TRAIL ASSESSMENT REPORT

Trail Name(s): Blue Trail and Yellow Trail

Property: Bowdoinham Town Property

Assessment Date: 6/6/2023

Map 1: GPS track showing assessed trail with slope readings

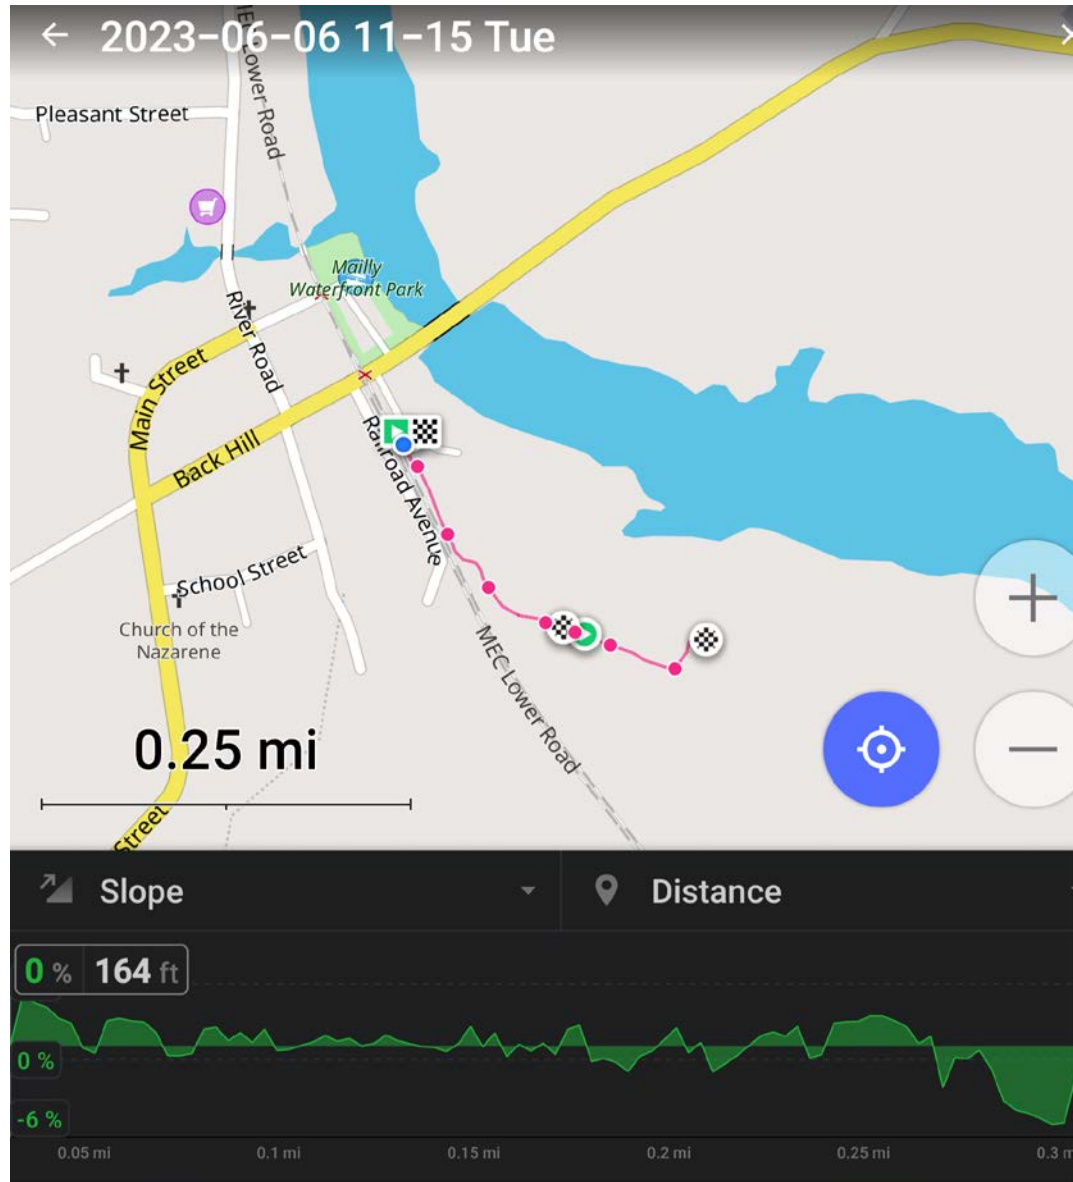
- Length of trail assessed: **0.27 mi**
- Surface types: **Mud/Grass/Rocks**
- Tread width – typical: **10 ft**
- Tread width – minimum: **3 ft on Yellow Trail Section**
- Running slope – typical: **0%**
- Running slope – maximum: **5%**
- Side slope – typical: **0%**
- Side slope – maximum: **<2%**
